## JABIRU AIRCRAFT PTY LTD

# Engineering Report: AVDALSR087-1

Subject: Procedure For Upgrading 12 Pole Alternator

Figure 3 - Terminal exposure

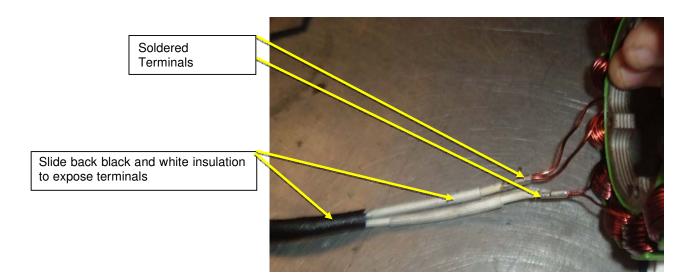
- 5. Cut string holding the harness to the stator assembly and straighten out the lead assembly. Slide back the black and while layers of insulation to expose the 2 terminals connecting the coil wires.
- 6. Unsolder coil wires from both terminals, as shown in Figure 3. Due to the size of these parts a large soldering iron or a small gas burner is recommended to get enough heat into the connection. Take care not to damage the insulating lacquer on the wires.

Figure 4 – Circuit identification

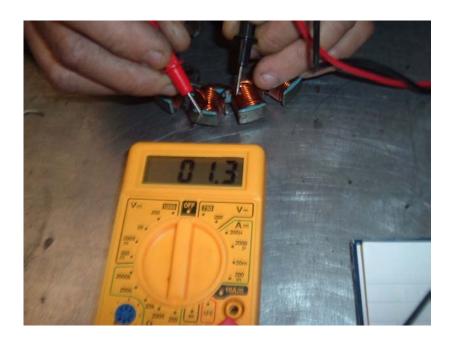
7. With the coil wires exposed, use a multimeter to identify which wires have continuity and those that don't, a typical reading for each continuous wire will be 1.3 - 1.4 ohms. Multimeters equipped with continuity test features (beepers) can also be used, provided that the resistance threshold is set appropriately.

Figure 5 - Twisted wire connection

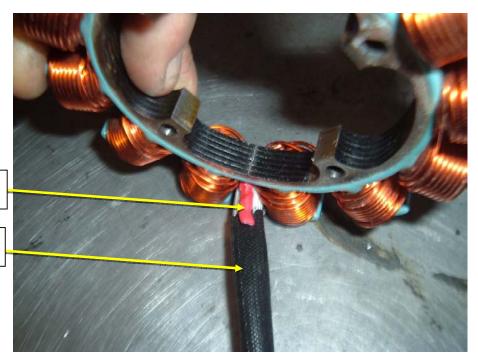
8. Twist any 2 wires together that do not have continuity, solder and insulate with heat shrink. Fold down between the coils. Take care that the connection is appropriately insulated, restrained and positioned: over time parts rubbing are likely to eventually damage the insulating lacquer on the wires and produce a short. Note that loads and vibrations applied to the alternator assembly from the magnets of the rotor are of relatively high magnitude and parts must be treated appropriately.

Figure 7 - Wiring Schematics

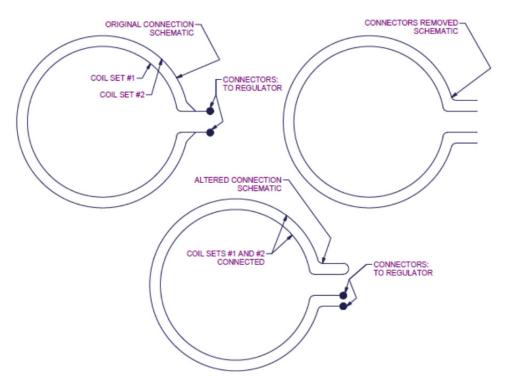
At manufacture, the 12 pole stator assembly was wound with 2 circuits in parallel. This reduces the effective length of the windings, limiting the output at low engine RPM. By re-connecting the wound coils on the stator in series, the effective length of the windings are increased, with a corresponding increase to the output voltage. The procedure given below details how the change may be carried out to engines in service.

- 1. A schematic showing the current and altered wiring is shown in Figure 7.
- 2. Disconnect the battery before you commence any work.
- 3. Disconnect stator wiring terminals and harness wire ties, then remove retaining bolts holding the rear plate and stator assembly from the engine, as shown in Figure 1.

Coil resistance:  $1.4 \Omega$  to  $1.9 \Omega$

A.C. output: Up to 40 VAC at 3000 RPM
